**City of Portland
Portland International Jetport
Phase I Parking Garage
City of Portland Major Site Plan Application
Response to Comments**

March 9 2001

**RE: Portland International Jetport - Phase I Parking Garage Improvements
Planning Board Submittal - Response to Comments**

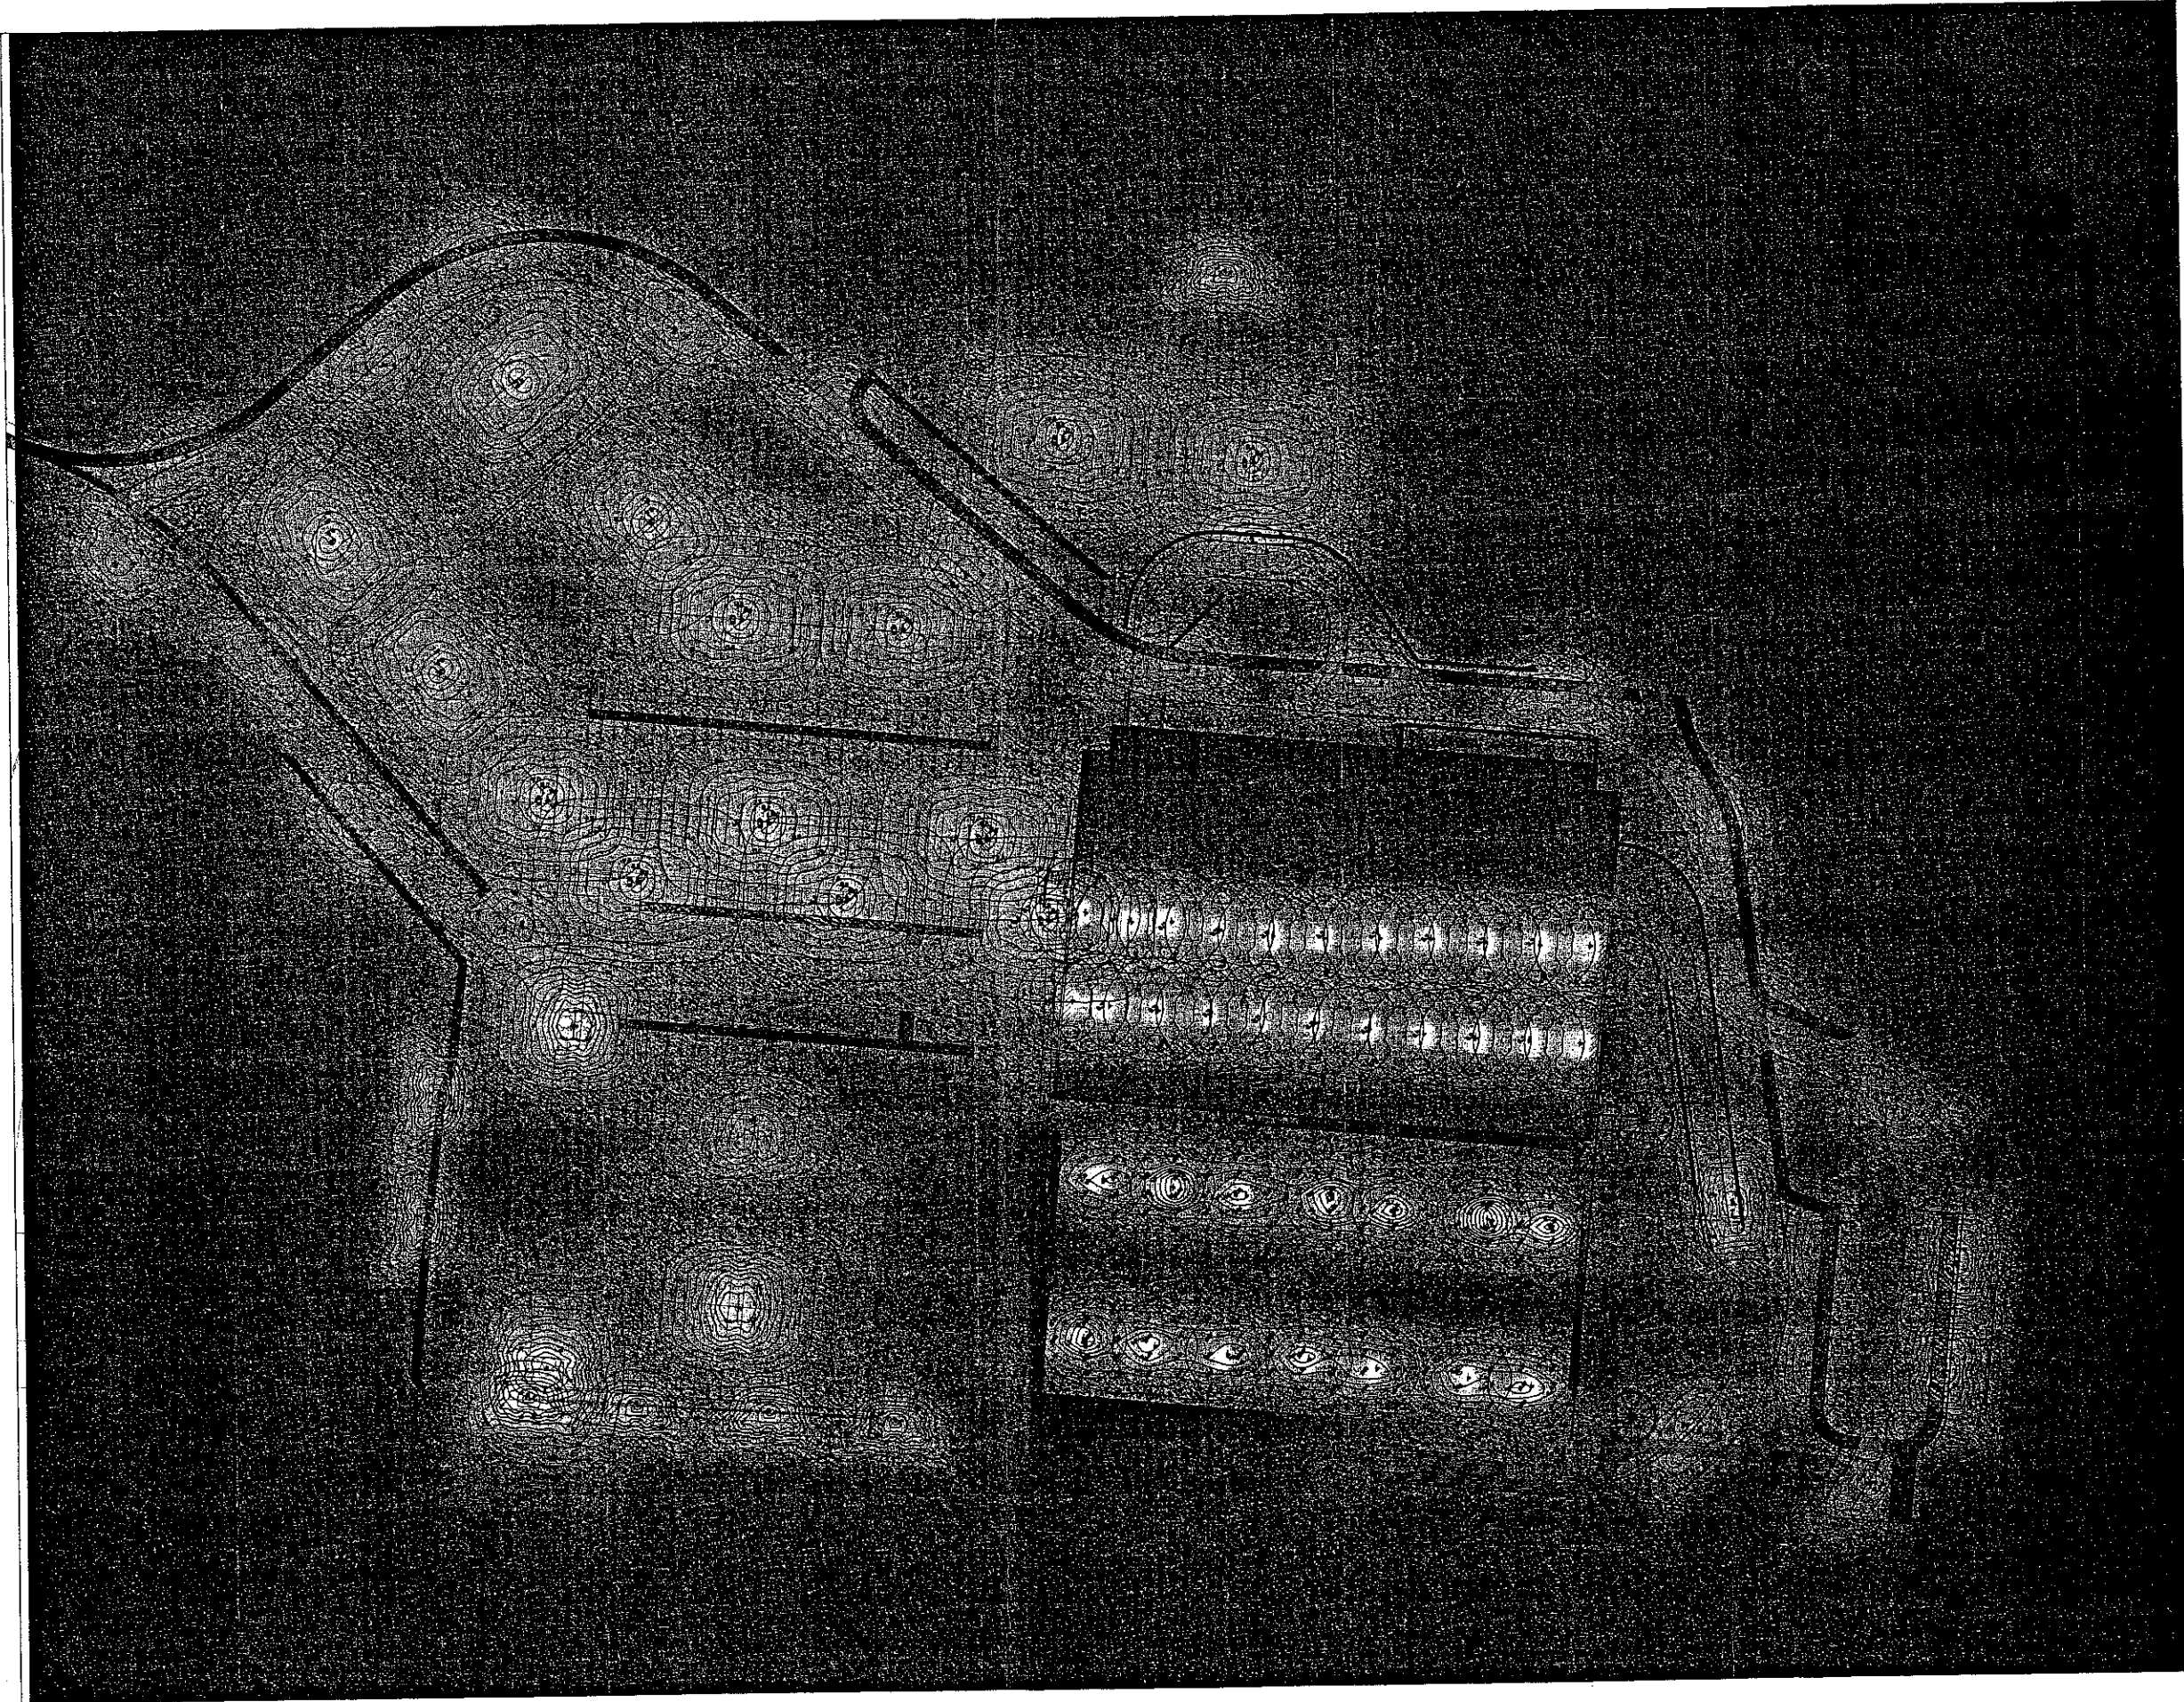
- ▶ **Lighting photometric values superimposed on a site plan have not been submitted. Internal parking garage lighting fixture catalog cut has not been submitted.**

- ▶ **With respect to the lighting plan, the photometrics are difficult to read, so I really don't have any comment, at this point. Lighting should be one of key elements covered in your planning board presentation. Also, I didn't see the fixture specs for the internal parking garage lighting fixtures.**

A photometric plan was submitted on February 27, 2001. The internal parking garage lighting fixture information is provided as Attachment B.

Information regarding the internal fixtures to the Parking Garage is provided as Attachment B. We plan to cover the photometric plan and its significance at the Public Hearing.
